THESE ARE THE SCHEMATICS FOR COMBO STAR

# MODIFIED PICaSTAR IF BOARD section

Title: PICaSTAR IF PCB (BASED ON G6ALU)

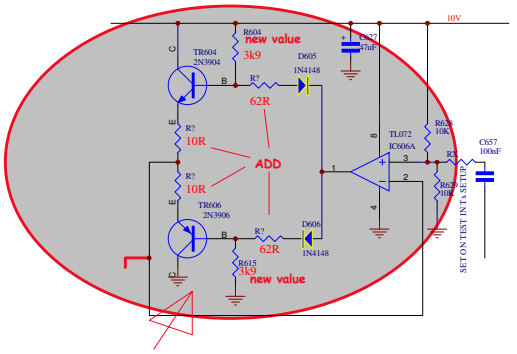
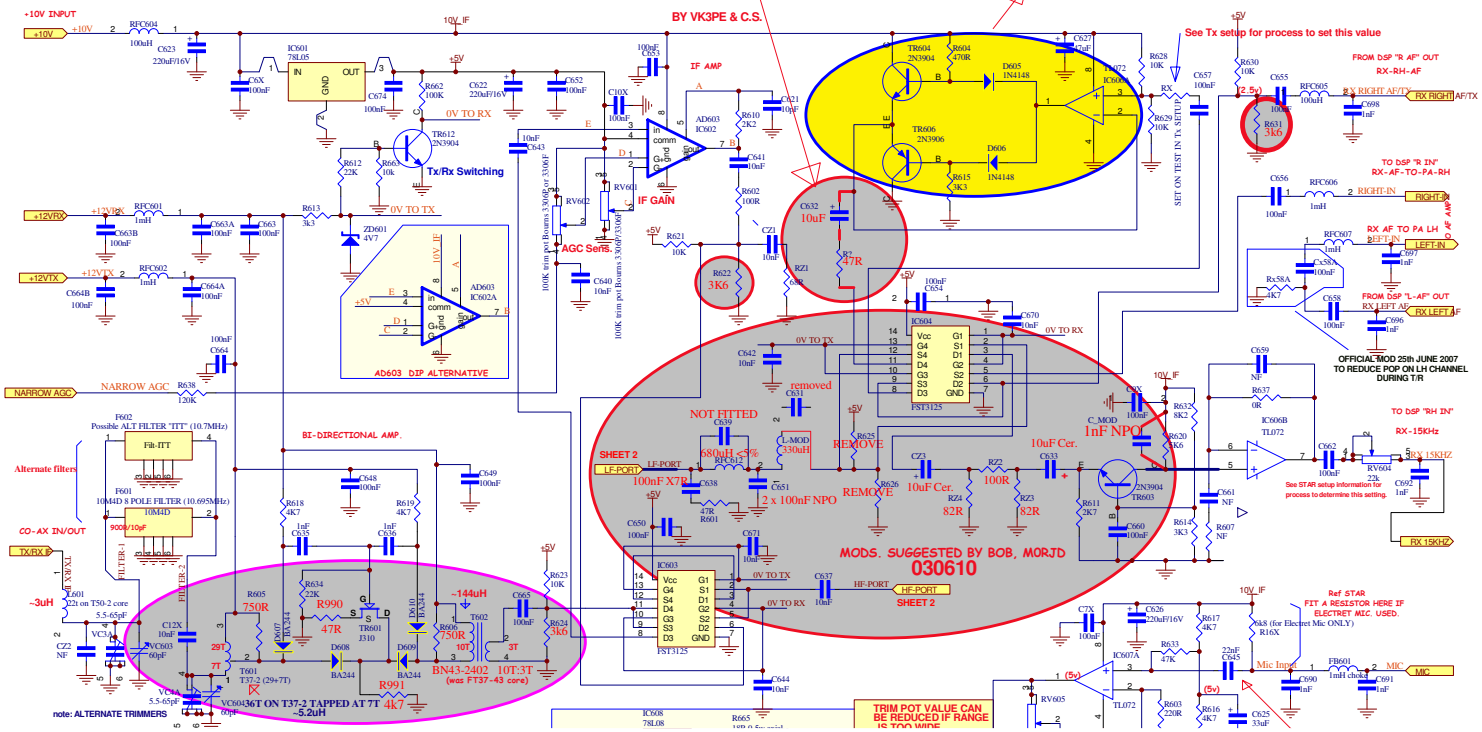
TRANSMIT-ONLY PATH:

C632 changed to 10uF (ceramic)
and 47R fitted in series
(need to stand parts and join in centre

This section is changed as per the above.
